# Duquesne Light Company

**Subject: Beaver Valley Power Station, Unit No. 2  
Docket No. 50-412, License No. NPF-73  
Operating License Amendment No. 73 Safety Evaluation Report**

# BVPS Unit 2 Miniflow System Arrangement

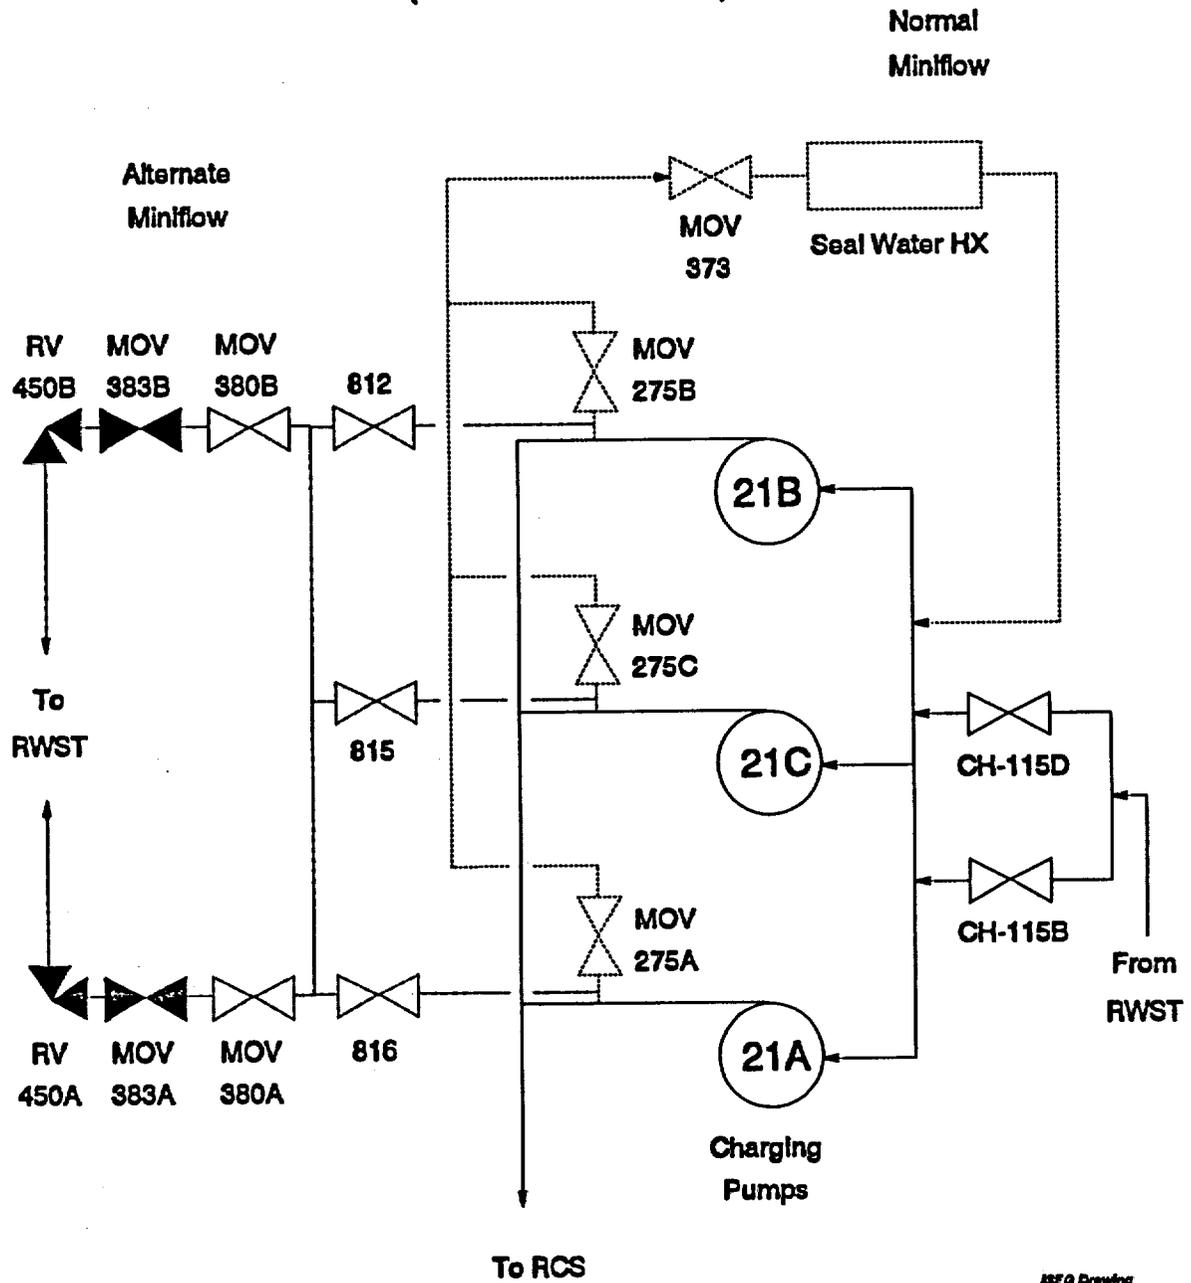
The first statement in Section 2.0, Background, states, "The subject valve is located in the alternate minimum flow system." As shown in the attached figure, 2CHS\*MOV373 is located in the normal minimum flow system.

In the second paragraph of the background section, the NRC states "...the licensee retired the AMFS in place by keeping the subject valve in the open position and removing its SI closure signal." It is true that the AMFS was retired in place. It is also true that 2CHS\*MOV373 is maintained in the open position and the safety injection (SI) closure signal for this valve was removed. However, the AMFS was retired in place by closing the valves associated with this system (i.e., 2CHS\*MOV383A, B and 2CHS\*MOV380A, B) to prevent flow through the AMFS.
